*The Reno Creek ISR Project
Campbell County, Wyoming*

**Revised RAI Response Package:
Technical Report**

December 2014

Figure 2.6A-18
Ore Body Area 1
Structural Cross Section F - F'

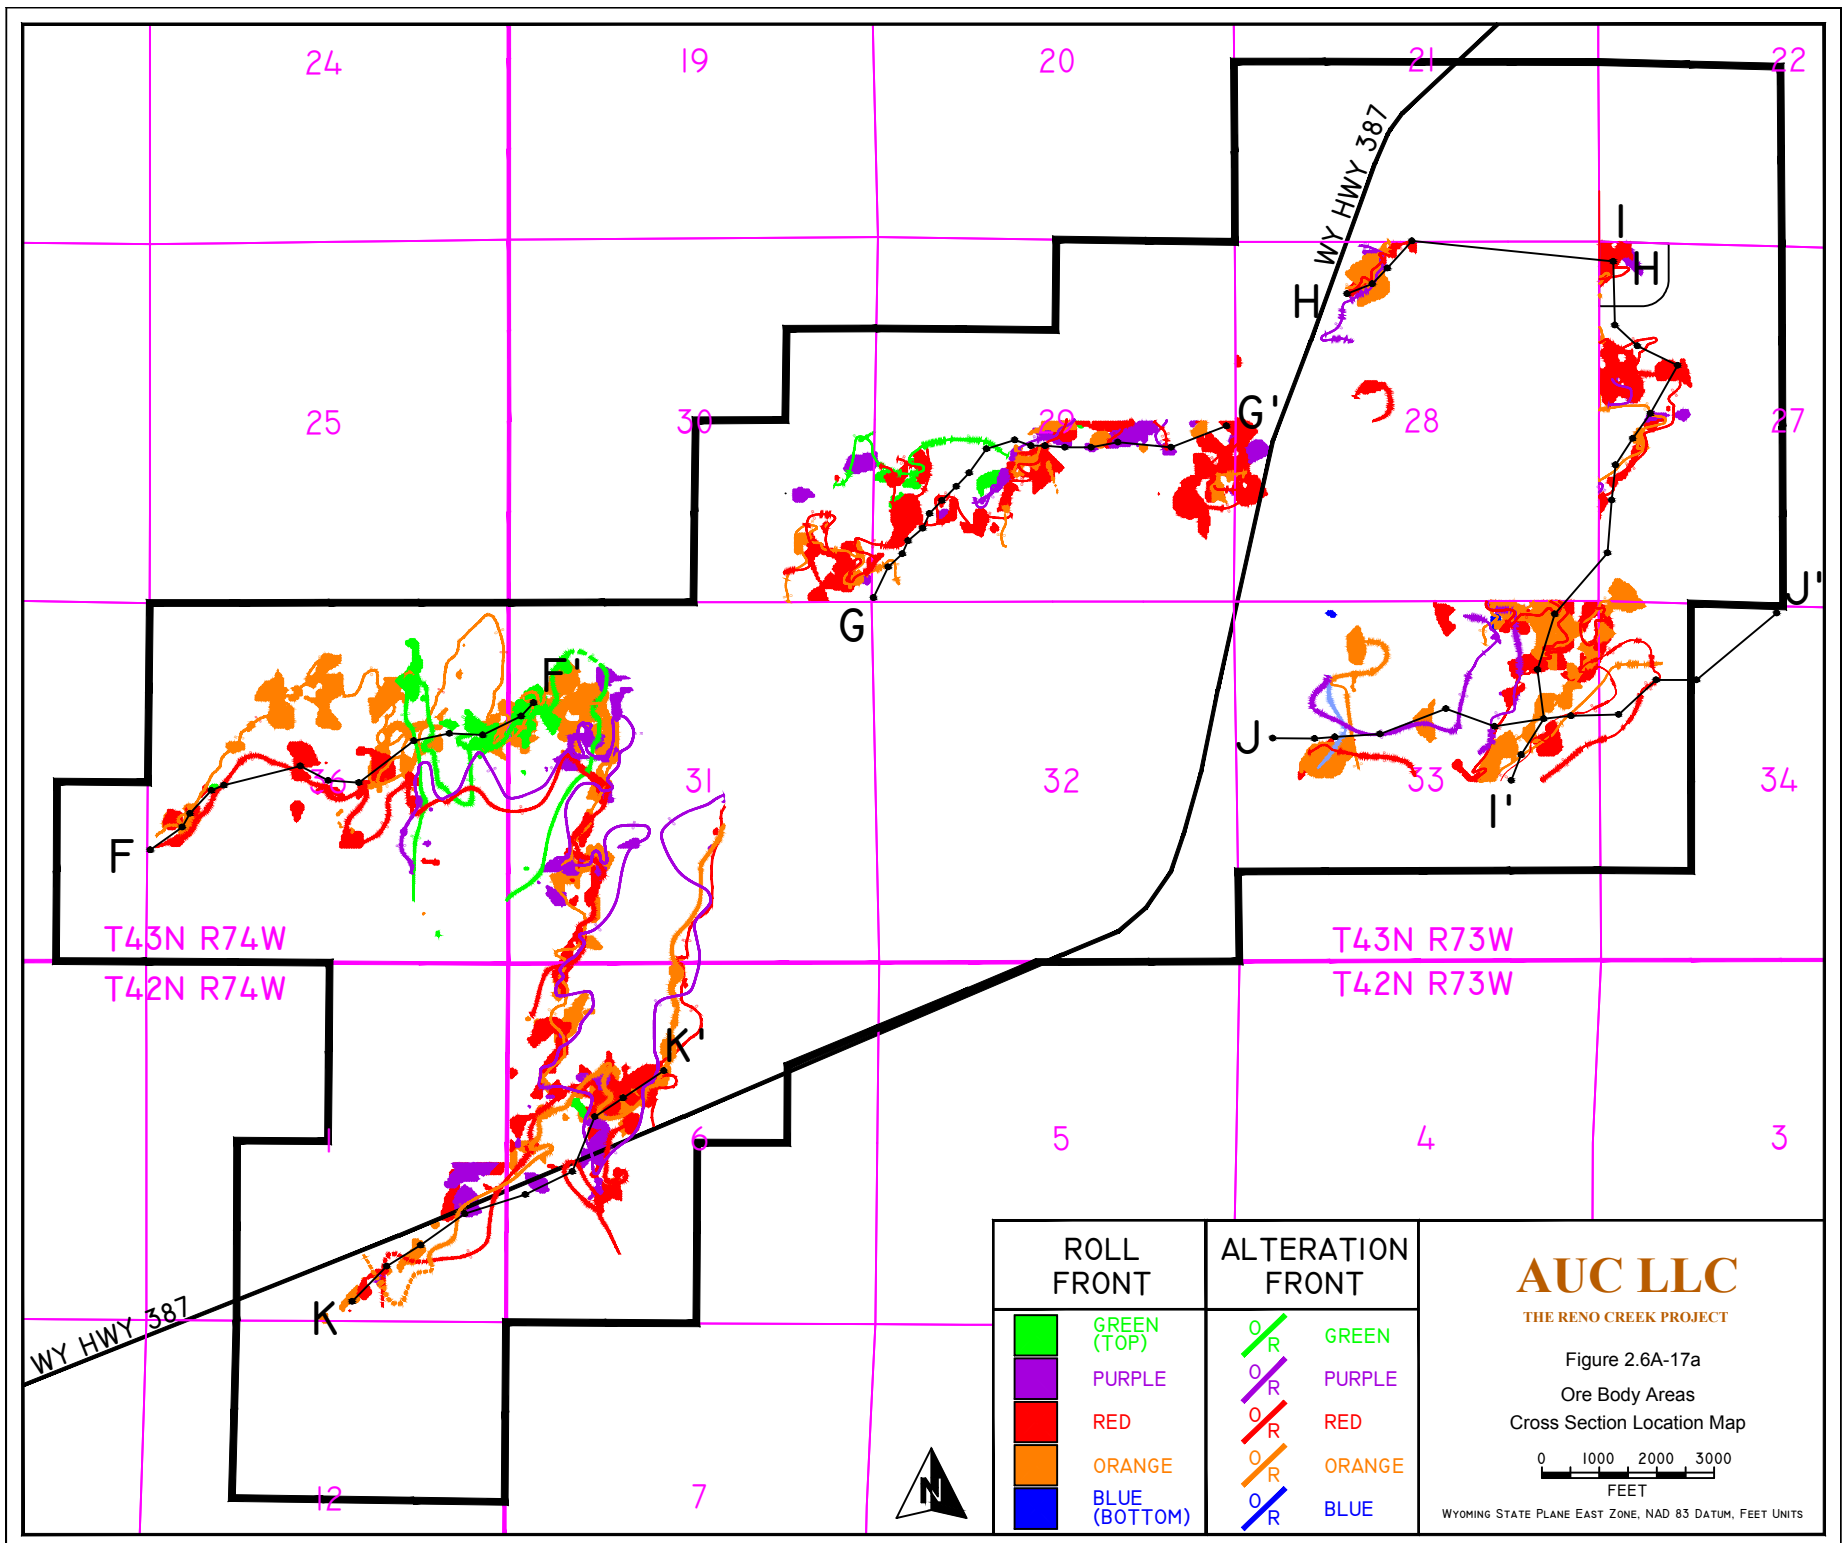
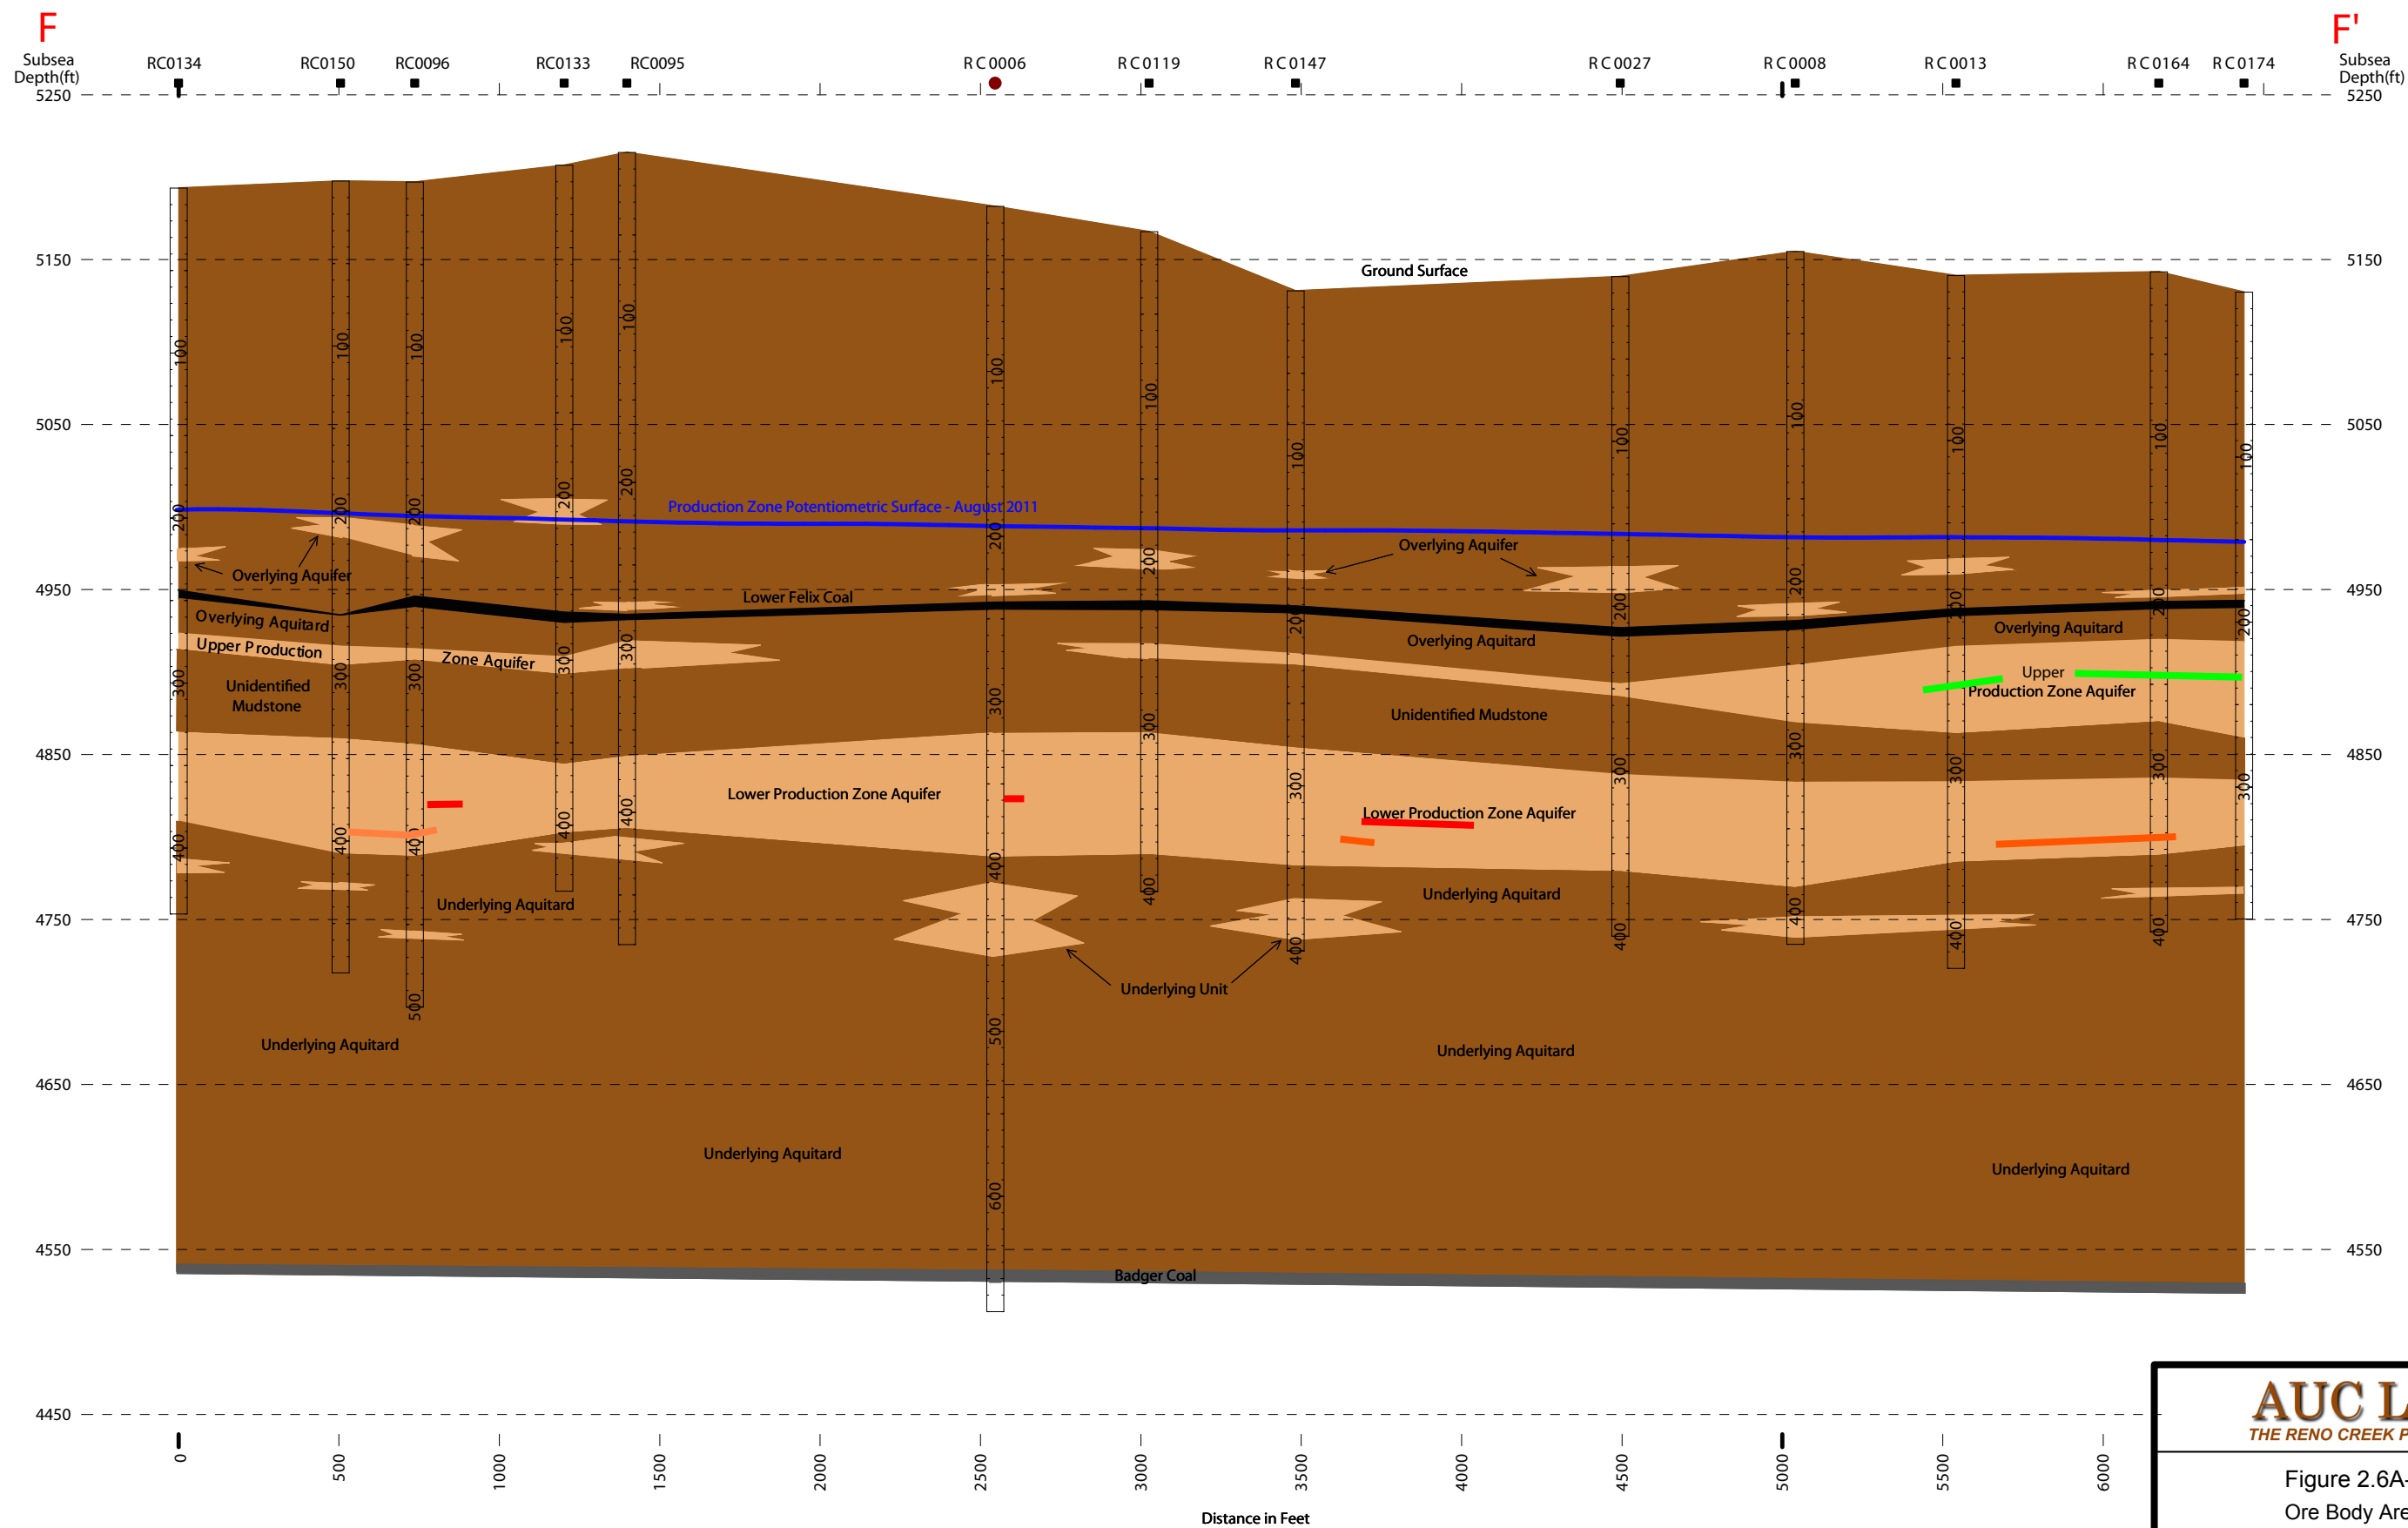
- a) Please provide mapping (including depicting the ore body on the cross-sections) that demonstrates the ore trends including the oxidation and reductions zones.*
- b) Please clarify whether or not Figure 2.6A-17 displays all ore-trend labels, including oxidation and reduction zones.*

On Figure 2.6A-27, the application presented a cross-sectional view of a typical roll front; however, the application did not include cross-sectional views of the ore body within the production zone aquifer throughout the project area (e.g., Figures 2.6A-18 through -23).

“At various localities within the Proposed Project area all horizons from the base to the top of the host sandstone (PZA) can be favorable for uranium deposition. However, economically significant uranium mineralization occurs most frequently in the lower half of the PZA. This relationship and **depiction of the ore trends, including oxidation/reduction boundaries is shown on Figure 2.6A-17. Cross sections depicting the vertical stacking of the ore trends are included as Figures 2.6A-18 through 2.6A-23.**”

Figure 2.6A-17 and Figures 2.6A-18 through 2.6A-23 are shown below:
